**Connecticut Department of Transportation**

**State Project No. 0156-0184  
Federal-Aid Project No. 1156(110)  
Replacement of Bridge No. 03612  
West Haven & New Haven**

**June 27, 2024 at 6:00 p.m.  
Virtual Meeting via Zoom and YouTube Live**

**Minutes of Public Informational Meeting**

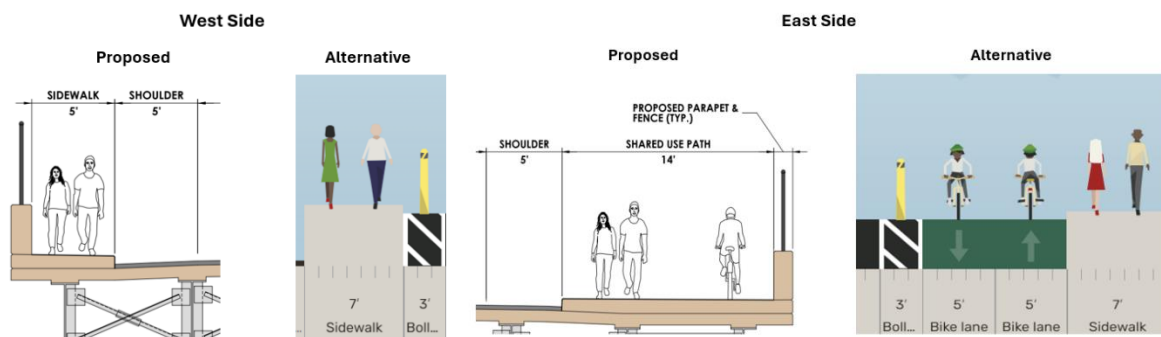
Email Question: Please take measures to protect pedestrians along the proposed new bridge to West Haven. Concrete barriers to protect the bike lane and pedestrians from cars should be added, along with raised crosswalks at the intersections.

Car accidents involving pedestrians can be avoided if protections are put into place to keep everyone safer and reduce driving speeds.

*Project Team Response: The project will balance the needs of all users, including vehicles, bicyclist, pedestrians and boaters. The comments will be considered as the design of the project progresses.*

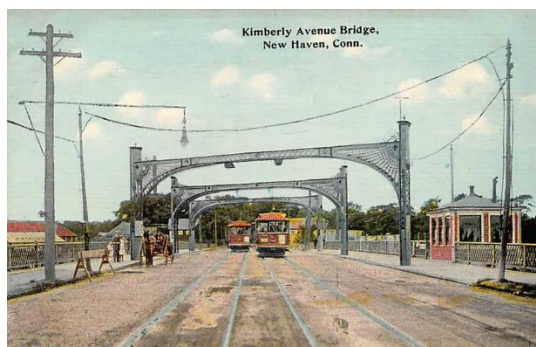
- **Activation Elements:** Historically, this bridge featured streetcars, wide sidewalks, and viewing decks overlooking the sea. While dreaming about streetcars can be seen as a pipe dream, adding an overlooking deck on the east side could be possible and help activate the bridge. This will enhance the bridge's appeal for pedestrians and cyclists, providing a place to relax and enjoy the beautiful sea views.

*Project Team Response: The project will balance the needs of all users, including vehicles, bicyclist, pedestrians and boaters. The comments will be considered as the design of the project progresses.*
